**Notice of RCRA Class 1 Permit Modification
in Accordance with 20.4.1.900 NMAC
(incorporating 40 CFR Part 270)**

**Waste Isolation Pilot Plant
Carlsbad, New Mexico**

July 20, 2000

Table 1. Class 1 Hazardous Waste Facility Permit Modification

Item 5. b. Revised Figure H-1

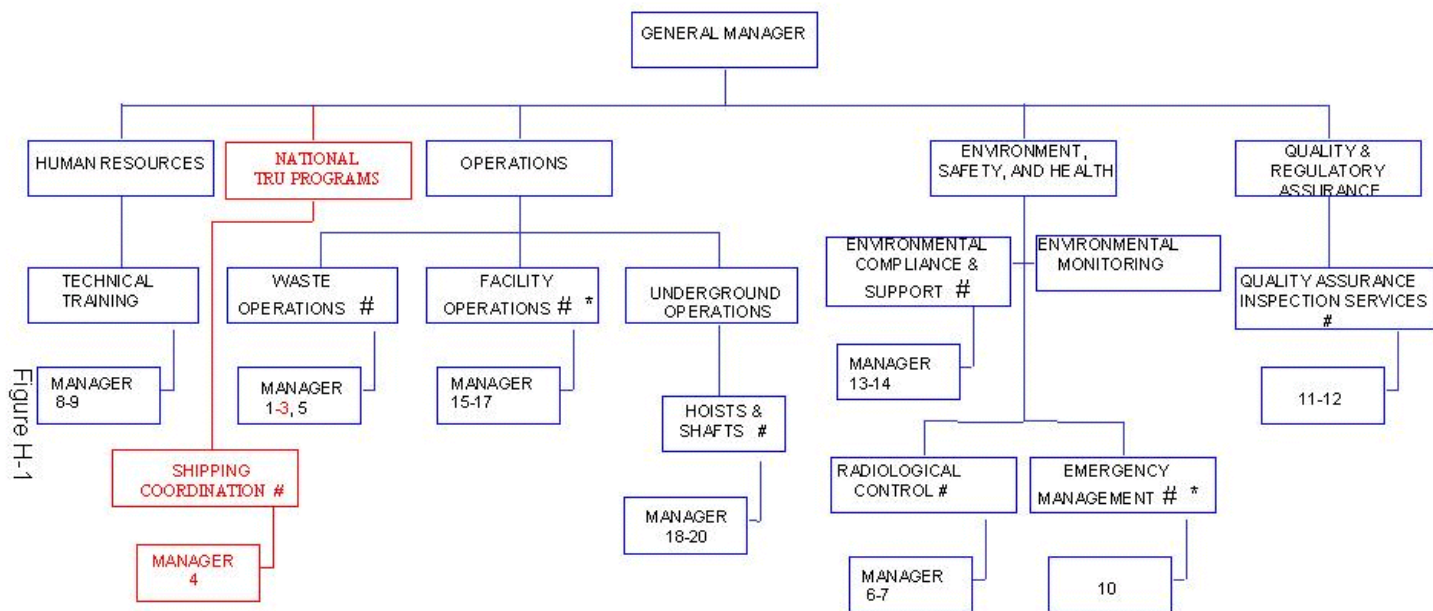
- a. Correct referencing to acronyms to make the text consistent. Correct regulatory references.
- b. Provide new figure (Figure H-1)

- a. Typographical and administrative changes to assure consistent referencing to acronyms and to applicable regulatory standards.
- b. Previous permit modification have only indicated the changes to Figure H-1. This modification provides a revised copy of the entire figure.

- a. Because these are administrative in nature, they are Class 1 changes that do not impact the ability of the permit to protect human health and the environment.
- b. Administrative change to provide an updated figure reflecting changes made on previously submitted Class 1 modifications.

The revised Figure H-1 is included in Attachment B.
